ST. TAMMANY PARISH

Addendum No.: 1
Bid#: 308-00-18-14-2
Project Name: 2018 District 8 Panel Replacements
Bid Due Date: July 11, 2018

| CONCRETE CATCH BASIN CURB OPENING 4" MOUNTABLE OR 6" BARRIER CURB MAX. PIPES: 42" X 72", MAX. DEPTH: 12' STANDARD PLAN CB-06 | | | | | | | |

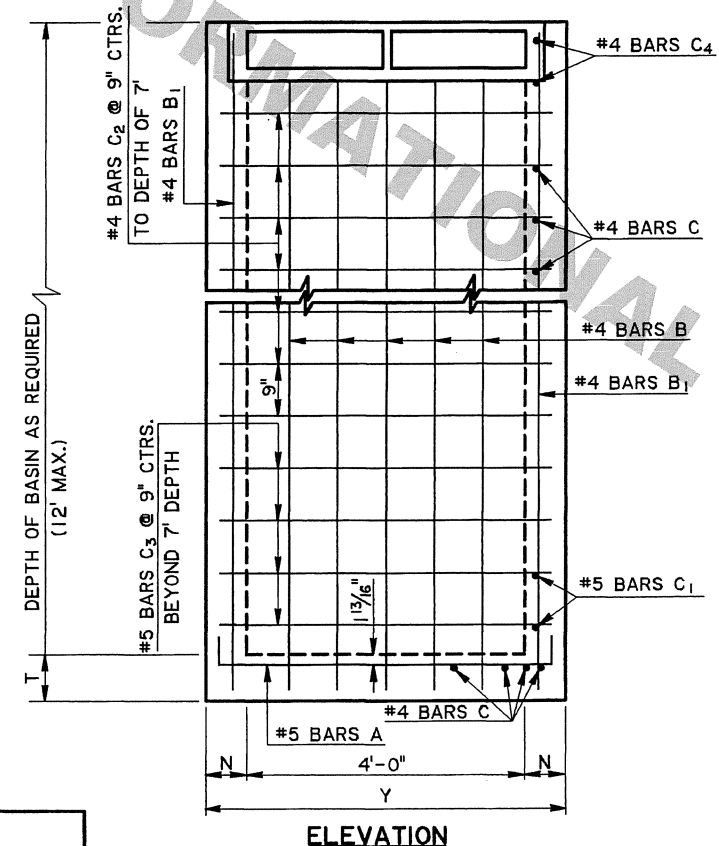
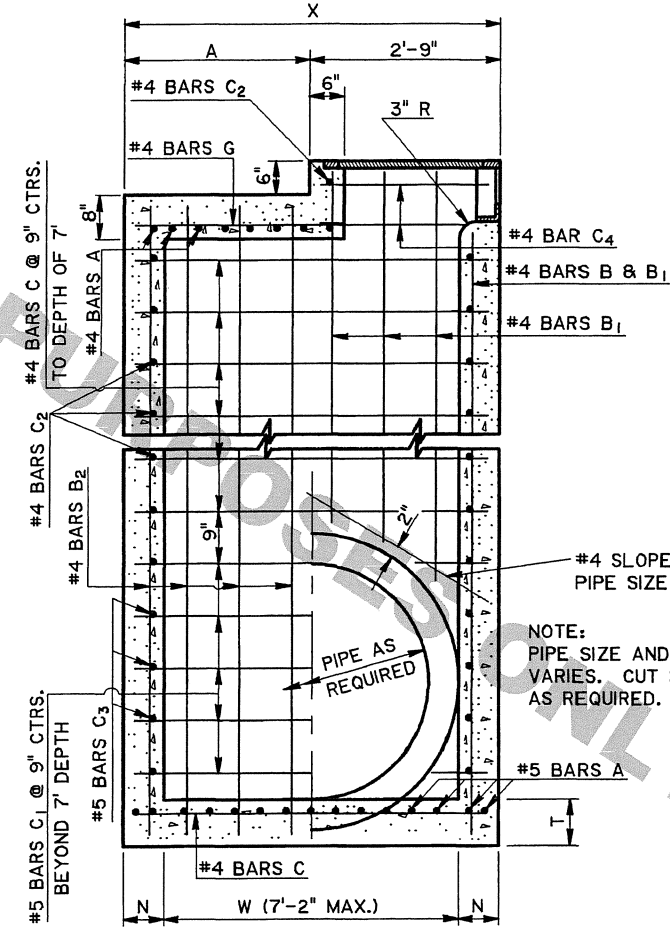
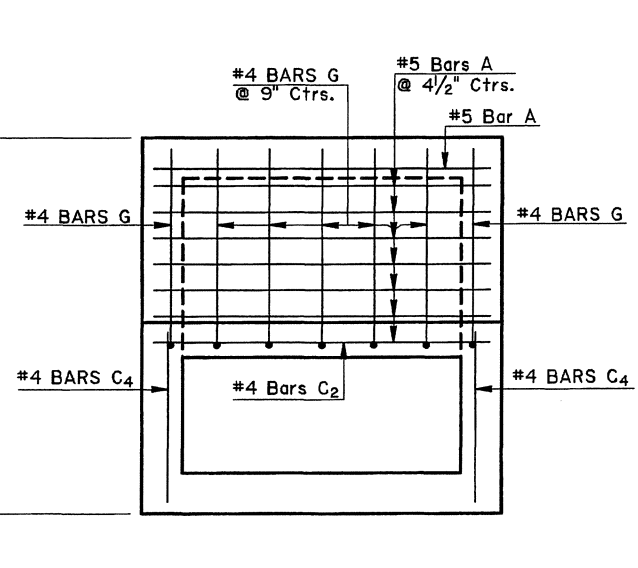
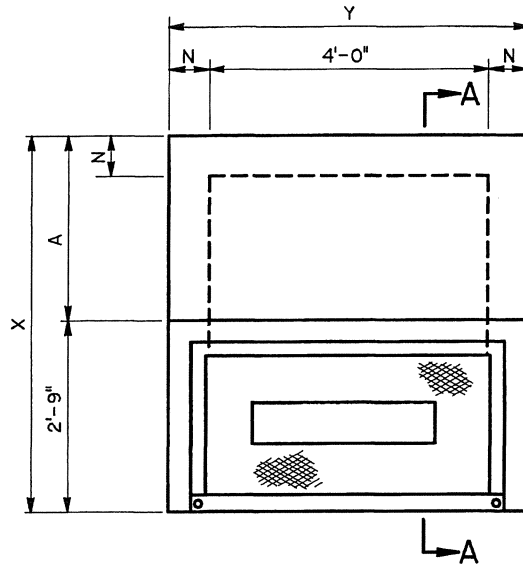
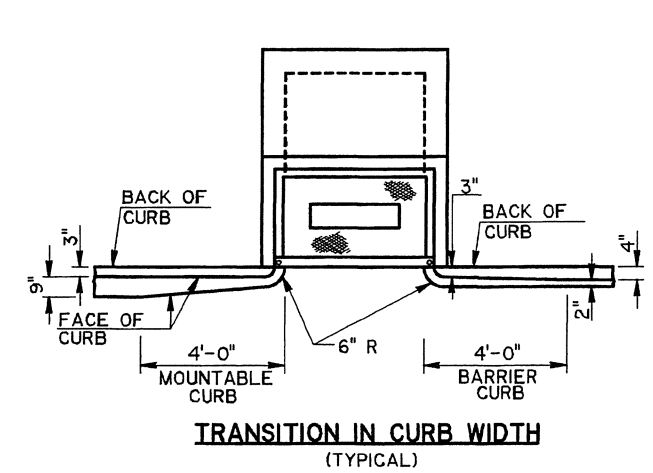
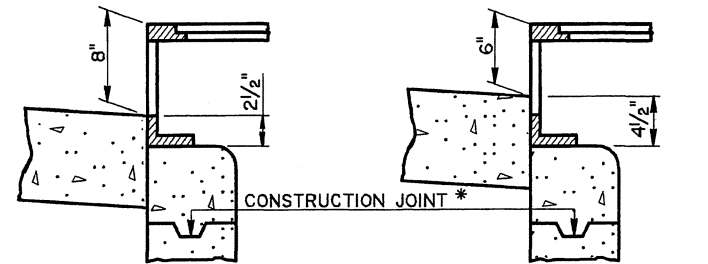
Question #9: Can the government provide a detail for the CB-07?

Question #10: Are these CB-07 to be cast in place or brick or precast?

Answer #9: Yes, except the catch basin will be changed to a CB-06.

Answer #10: The specification clearly states the catch basin shall be pre-cast or cast in place.
